PRODUCT CHANGE NOTIFICATION (PCN)

AMJE0909-0150-BNB-24
MODULAR CABLE

CHANGE NOTIFICATION: PCN 20220509_AMJE0909-0150-BNB-24

DESCRIPTION OF CHANGES:
CHANGE OF DATA SHEET
CHANGE OF DATA SHEET
New Draw.-No. ASS_7945_CArev02

AMJE0909-0150-BNB-24 OLD VERSION

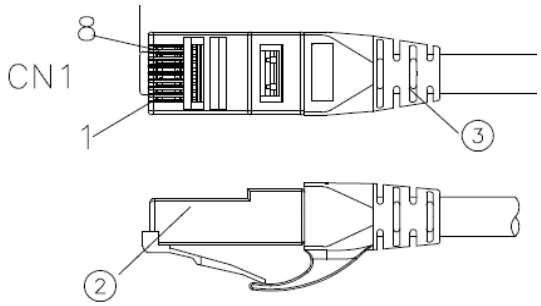
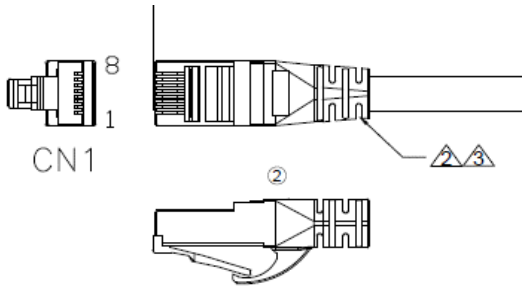
③	Molding	PVC 45P Color: see order code	NA	KG
②	CONNECTOR	RJ45 8P8C two fork Short type 3u" gold plated	2	PCS
①	CABLE	CAT6 UTP (24AWG*1PR)*4+PVC OD=5.8±0.3MM Color: see order code	NA	MM
NO:	NAME	DESCRIPTION	Q'TY	UNIT

3	Molding	PVC 65P Color: see order code ②	NA	KG
2	CONNECTOR	RJ45 8P8C PLUG 3u" gold plated ②	2	PCS
1	CABLE	CAT6 U/UTP (24AWG*1PR)*4+Cross+PVC Jacket OD=5.8± 0.3MM Color: see order code ②	NA	MM
NO:	NAME	DESCRIPTION	Q'TY	UNIT

Drawing-No.
ASS 7945 CA

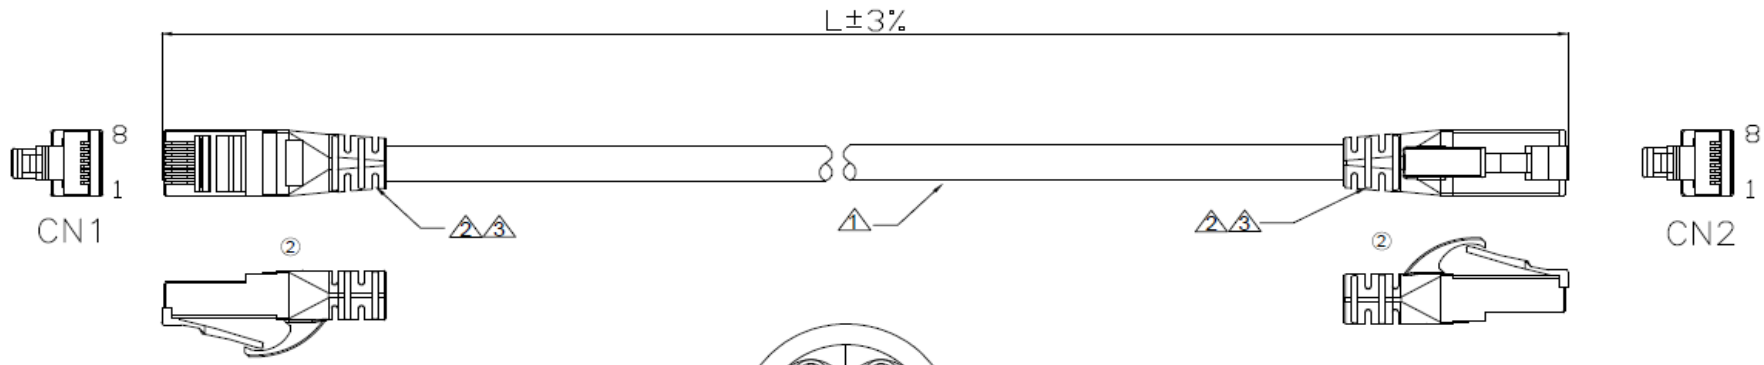
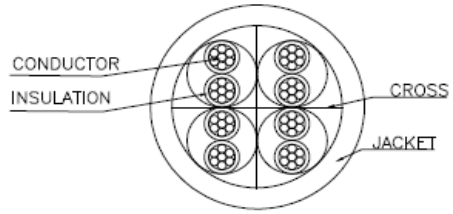
Id.	Modification	Date	Name
②	Change the plant	09.05.2022	Luca
①	Update the WSW order code	02.06.2017	Amy
⓪	Drawn	30.03.2017	Amy

NO:	NAME	DESCRIPTION	Q'TY	UNIT
3	Molding	PVC 65P Color: see order code ②	NA	KG
2	CONNECTOR	RJ45 8P8C PLUG 3u" gold plated ②	2	PCS
1	CABLE	CAT6 U/UTP (24AWG*1PR)*4+Cross+PVC Jacket OD=5.8± 0.3MM Color: see order code ②	NA	MM
